**SUBJECT: NINE MILE POINT NUCLEAR STATION – INTEGRATED INSPECTION  
REPORT 05000220/2017001 AND 05000410/2017001**

Report Nos. 05000220/2017001 and 05000410/2017001

Facility: Nine Mile Point Nuclear Station, LLC (NMPNS)  
Units 1 and 2

Figure 1

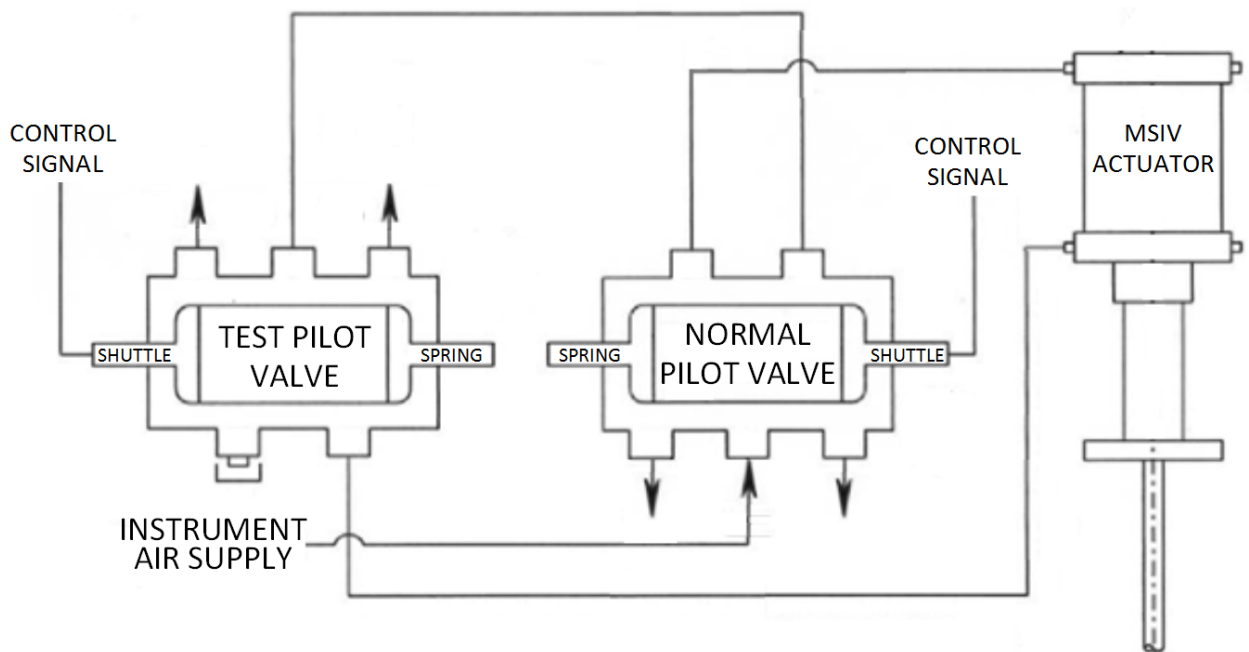
On December 10, 2016, MSIV 01-04 failed to close during surveillance testing. An Exelon investigation discovered that the MSIV failed to close because the pilot valve was bound. This is similar to an event that happened in September 2015 where MSIV 01-03 continued closed during a partial stroke test, eventually leading to a scram. The cause for the complete valve closure was also due to a bound pilot valve. The inspectors recognized that the valves are commonly supplied with instrument air for valve control, so following the December 2016 failure, the inspectors conducted a walkdown of the instrument air system and reviewed the system maintenance and testing program. The inspectors noted that since May 2016, particulate greater than the 40 micron requirement described in the Unit 1 UFSAR was discovered in the instrument air system, constituting a sample failure. These failures were documented in IRs 02676351, 02703052, and 03949765. The sampling process takes samples from various locations in the instrument air system to determine the quality of the whole system. Section X.I.3.0 of the NMPNS UFSAR states, "Reliable operation of instrument air end users and in-line components is dependent on the filtration and removal of particulates greater than

40 microns. Additional filtration for various components exists where the 40 micron limit is not satisfactory.” The inspectors recognized that the 5 micron clearance of the outboard MSIV pilot valve would require filtration to remove particulate much smaller than 40 microns, however none exists between the instrument air sampling points and the pilot valves. Without additional filtration for particulate greater than the 5 micron clearance of the pilot valves, there is a potential for foreign material to become lodged between the shuttle and the cage locking it in position. If the pilot valves are unable to change position, the MSIVs might not operate as seen in both the September 2015 and December 2016 events. Indeed, a subsequent Exelon Powerlabs report, following the December 2016 event, found that a potential cause of the pilot valve binding was due to foreign material being introduced by the instrument air system.

When the inspectors questioned why the MSIV pilot valves were not evaluated for susceptibility for damage due to foreign material following the failed surveillance, Exelon personnel stated the sample point closest to the MSIVs had not failed for high particulate, therefore they had not evaluated the pilot valves. The instrument air sampling process categorizes particulate quantities based on sizes of 3 to 20 microns, 20 to 40 microns, and greater than 40 microns. Any particulate discovered greater than 40 microns would constitute a failure in accordance with the Unit 1 UFSAR. However, given the 5 micron clearances that exist in the pilot valves, particulate found in any of those ranges would constitute a potential to impact MSIV control without additional filtration. The sample location closest to the MSIVs had historically been found to contain particulate in the 3 to 20 micron range, but the procedure did not require test personnel to alert Exelon supervisory personnel of the potential to damage the pilot valves.

Exelon’s immediate corrective actions included entering this issue into its CAP as IR 03959732, performing an air purge of the instrument air system to remove foreign material from the system, and replacing the current style pilot valves with new style valves with larger clearances during the spring 2017 refueling outage.
